FHWA-HI-EIS-80-02-F

ENVIRONMENTAL IMPACT STATEMENT FOR THE PROPOSED

SAND ISLAND ACCESS ROAD WIDENING

PROJECT NO. 64A-01-79

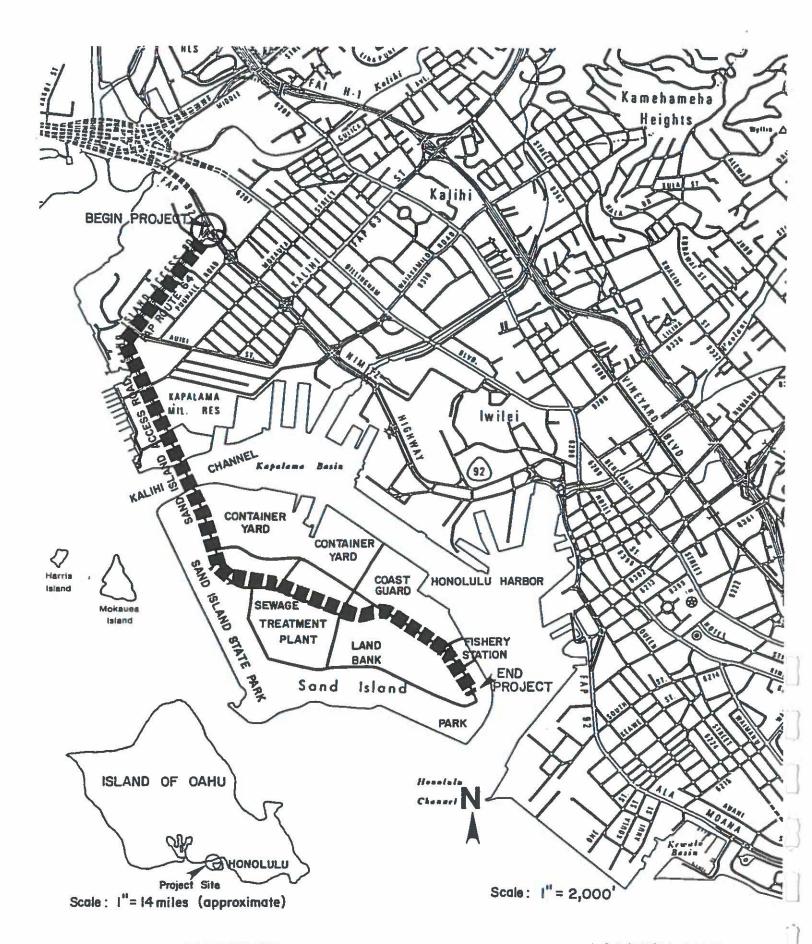
- 1. Figure 1 appears to be incorrect with reference to Figure 2.
- 2. If and when the unimproved portion of Sand Island Parkway is constructed, the drainage system serving the sewage treatment plant will have to be relocated. Local sewer lines in the vicinity will probably be affected.
- 3. Construction plans should be coordinated with the Drainage Section of the Division of Engineering and the Devign Branch of the Division of Wastewater Management.
- 4. According to our monitoring data, the new Sand Island outfall sewer is not causing any water quality problems in Mamala Bay, especially around Sand Island. Your statement on coastal water quality should be revised accordingly.
- We concur on the need of the proposed project.

- 1. Figure 1 identifies the location of the project, and Figure 2 shows the 1990 Honolulu Harbor Plan (proposed land uses).
- We will coordinate the drainage and sewer concerns with the appropriate parties as our plans are developed.
- We will note this information in the EIS document.

- 4D The information on the formation of Sand Island is corrected in the text on page 3-17.
- 4E The error in Figure 1, page 1-2 (Kabaka aulana Island should be correctly identified as Harris Island) has been corrected.
